Handicap Accessibility Review ADA / CT 504 Assessment Eno Memorial Hall

For the **Simsbury Senior Center**

Handicap Accessibility Review - ADA / CT 504 Assessment

PARKING

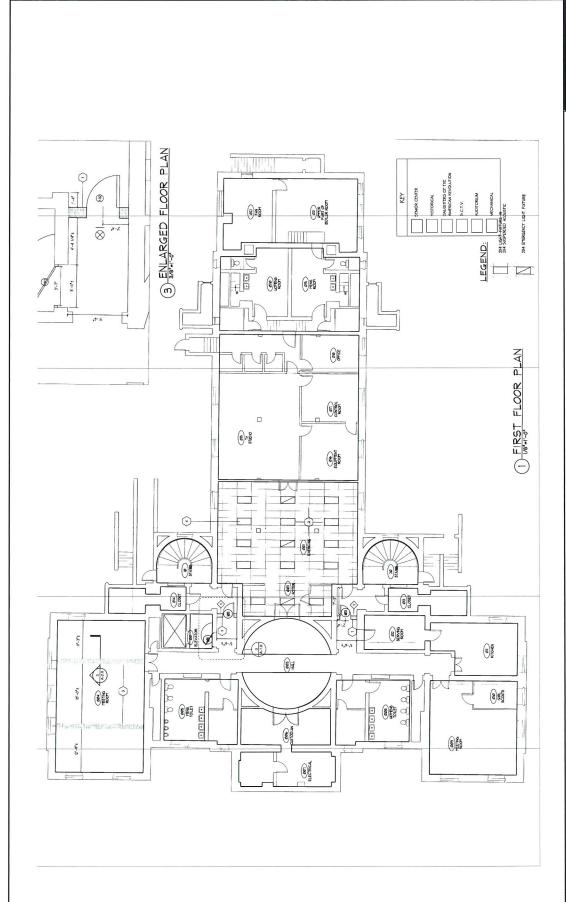
- HC parking spaces gradient exceeds the allowable percentage
- pavement torn up
- Accessible pathway surface irregularities exceed ½" in height
